Access Compliance Report

Public Rights-of-Way

(Curb Ramps)

Intersection ID: 45553	Main Street: MOUNTAIN_QUAIL_DR	Cross Street: ROOK_RD	Location: E
ADA ID: 2C1B681EB162	Ramp Type: PerpDiag	Initial Pass/Fail: Fail	Overall Compliance: No
Codes/Mitigation Info/Possible Solution		Field Measurements/Component Compliance	
Severity Score: 22.5

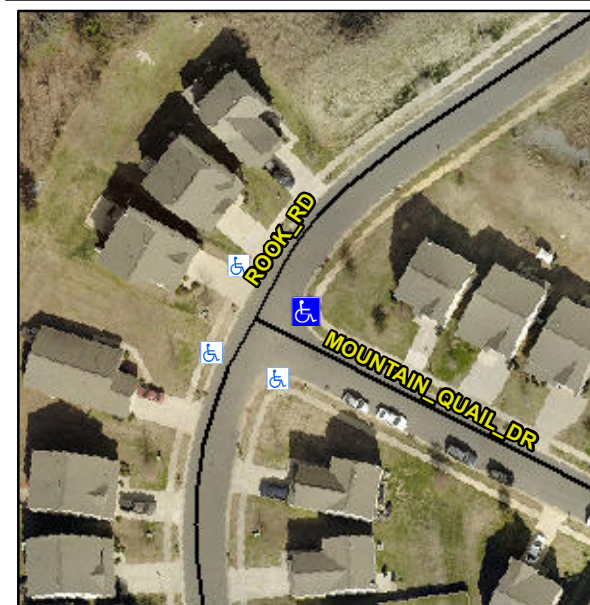
Not Found, R304.5.1, R304.2.2, R304.5.3

Compliance	Description	Data	Compliance	Description	Data
N/A	Ramp Length (in)	45.0	No	Ramp Slope (%)	8.8
No	Ramp Width (in)	47.5	No	Ramp XSlope (%)	2.5
N/A	Flare Type LT	N/A	N/A	Flare Type RT	N/A
N/A	Flare Slope LT (%)	N/A	N/A	Flare Slope RT (%)	N/A
N/A	Flare Traversable LT?	N/A	N/A	Flare Traversable RT?	N/A
N/A	Landing Length (in)	N/A	N/A	DWS Provided?	N/A
N/A	Landing Width (in)	N/A	N/A	DWS Contrast?	N/A
N/A	Landing Slope (%)	N/A	N/A	DWS Length (in)	N/A
N/A	Landing X Slope (%)	N/A	N/A	DWS Full Width?	N/A
N/A	Landing Curb? (Y/N)	N/A	N/A	DWS Offset (in)	N/A
N/A	Shared Landing?	N/A			
N/A	Gutter Ponding?	N/A	N/A	Gutter Slope (%)	N/A
N/A	Gutter Lip Ht (in)	N/A	N/A	Gutter X Slope (%)	N/A
N/A	Painted X Walk1?	No	N/A	Painted X Walk2?	No
	X Walk 1 Direction	To NW		X Walk 2 Direction	To SW
N/A	X Walk 1 Width (in)	N/A	N/A	X Walk 2 Width (in)	N/A
	X Walk 1 Slope (%)	1.8		X Walk 2 Slope (%)	0.8
	X Walk 1 X Slope (%)	2.4		X Walk 2 X Slope (%)	1.7

Remove & Replace Curb Ramp With Two New Directional Ramps or Equivalent.
